Plan Change Request

PCR 001
PRCCP20230970

SUBJECT: East Town Crossing Permit 1 Revision – Storm Memo

EAST TOWN CROSSING

DEVELOPED CONDITIONS BASIN MAP
(UPDATED)

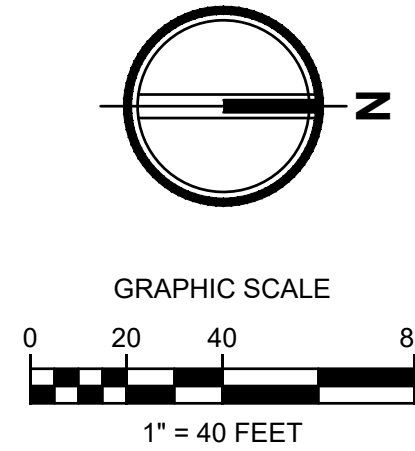
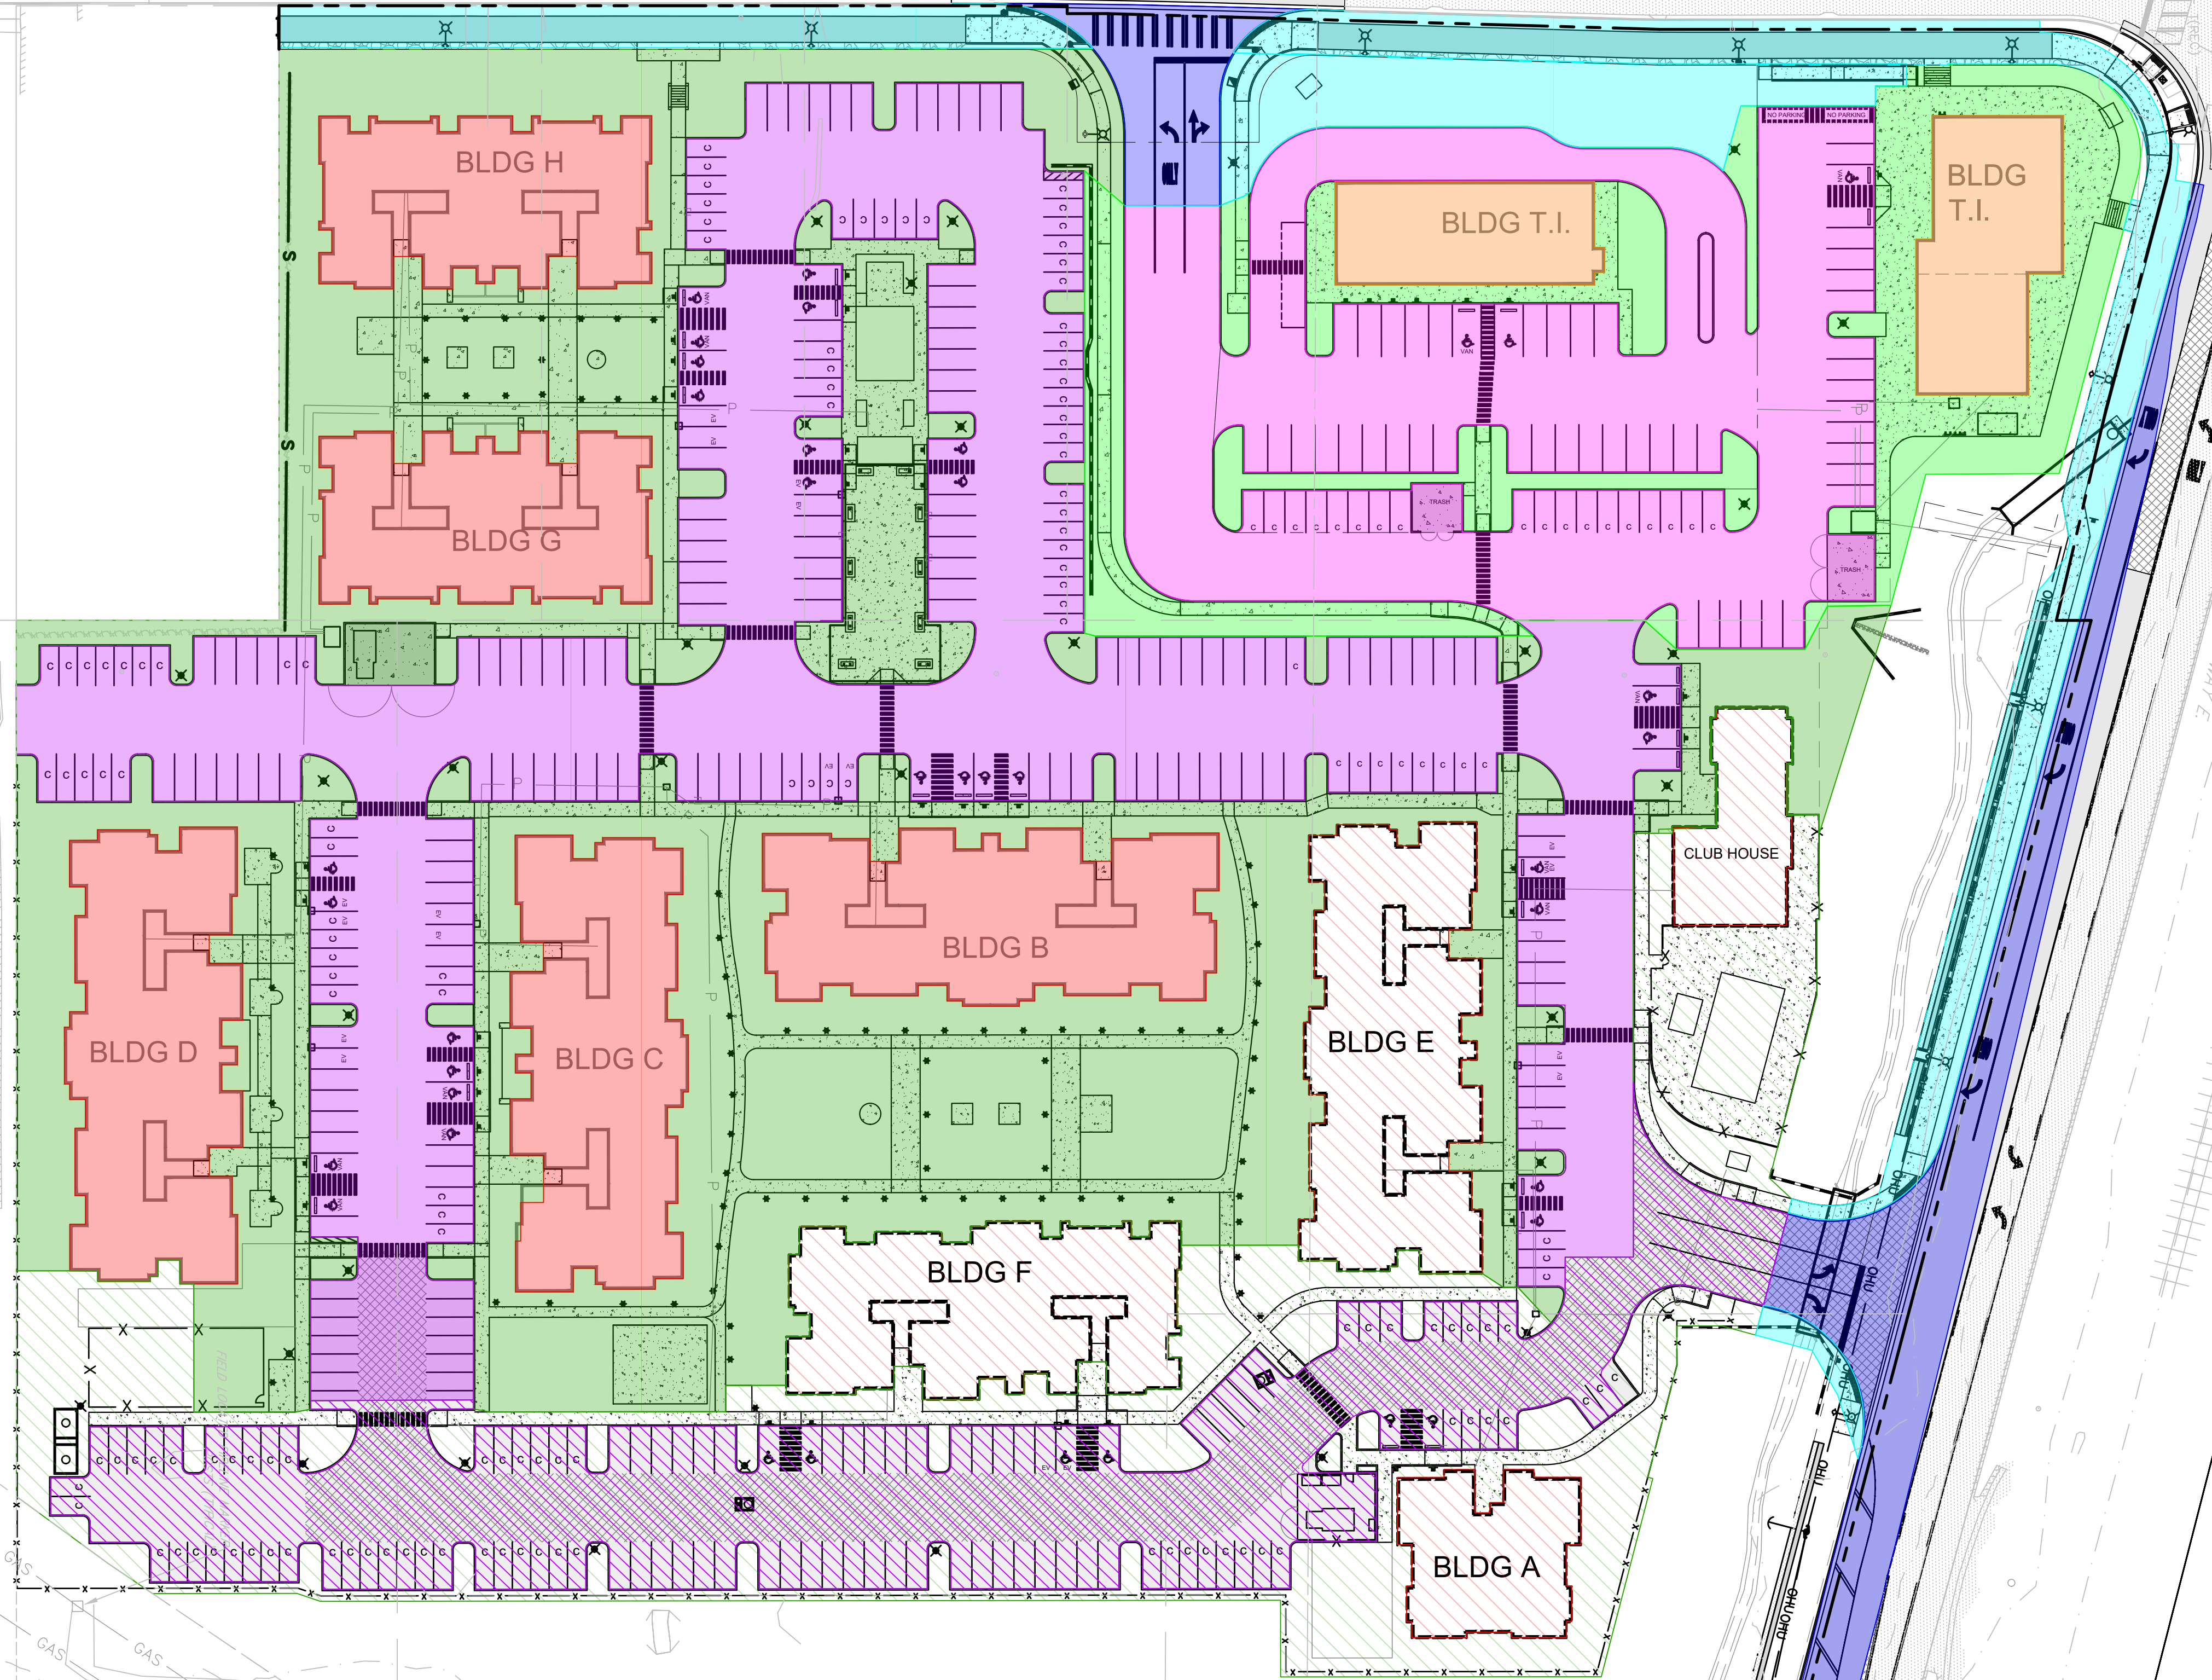
Phase 1 Permit Revisions impact each basin as follows:

Upper Basin (Residential):

- + 750 sf of pervious concrete sidewalk (modeled as lawn)
- + 1050 sf of lawn
- + 520 sf of roof area
- - 2320 asphalt roadway

Due to the overall reduction in impervious surfaces, by inspection, the existing storm system will not be impacted.

Lower Basin (Commercial):

- + 1750 sf of pervious concrete sidewalk (modeled as lawn)
- - 2000 sf of lawn
- + 100 sf of roof area
- + 150 sf of asphalt roadway

The overall addition in effective impervious area is 350 sf and is deemed negligible, thus will not impact the storm system.

- the permitted developed conditions basin map: Developed Conditions Basin Map A-3A
- the updated developed conditions basin map: Developed Conditions Basin Map (Updated) A-3A
